NOTICE OF PROPOSED CHANGE IN PROPERTY

Petition: x437 ✓

PETITION NO. 437
 MIDTOWN DETROIT
 3939 WOODWARD AVE.
 DETROIT, MICHIGAN 48201
 C/O SUSAN T. MOSEY
 PHONE NO. 313 420-6000

B					REQUEST TO VACATE A PORTION OF ALEXANDRINE AVE., 17 FT. WD. AND A PORTION OF SECOND AVE., 10 FT. WD. IN THE BLOCK BOUND BY SECOND, WILLIS, CASS AND ALEXANDRINE AVE.	CITY OF DETROIT CITY ENGINEERING DEPARTMENT SURVEY BUREAU
	A					
DESCRIPTION		DRWN	CHKD	APPD	DATE	JOB NO. 01-01 DRWG. NO. X 437
REVISIONS						
DRAWN BY WLW		CHECKED				
DATE 11-20-14		APPROVED

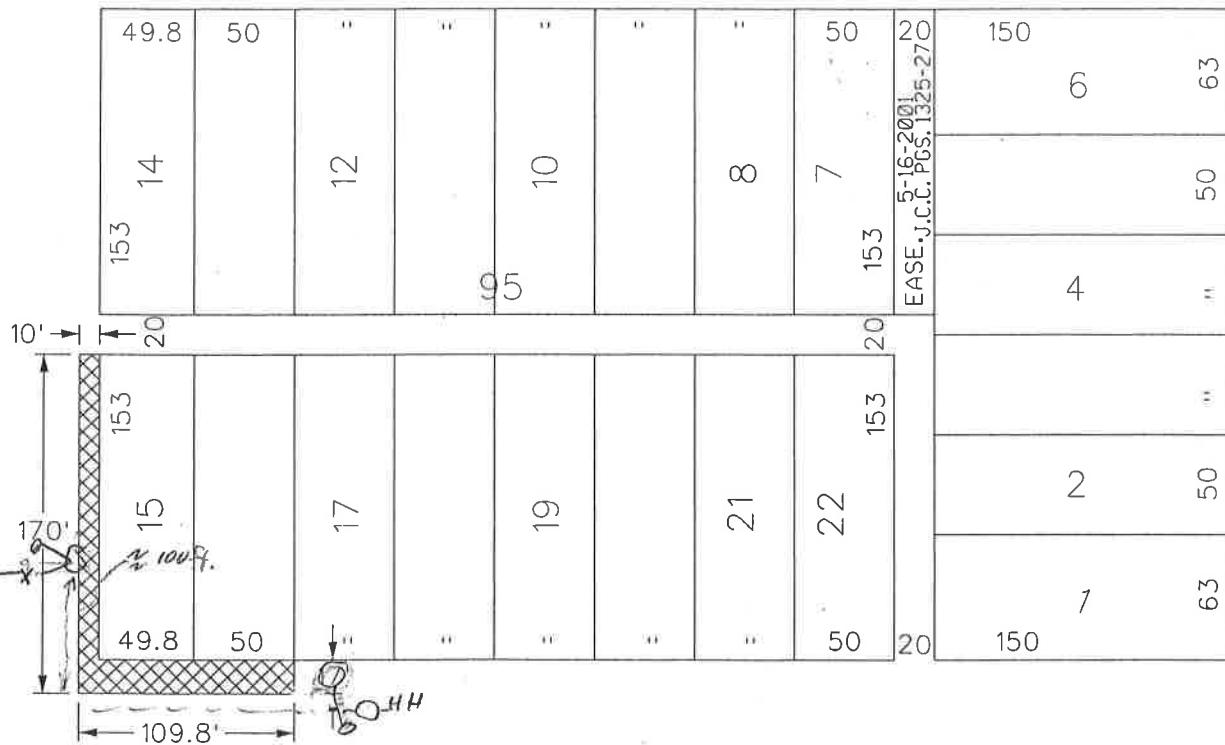
PLD has an underground-fed streetlight in the proposed area of vacation in Second. The streetlight should be relocated at project expense. The relocation should be in a manner that maintains the proper photometric scheme. Coordinate all work thru Denise Williams. Do not grant petition until the relocation is approved by PLD and work completed.
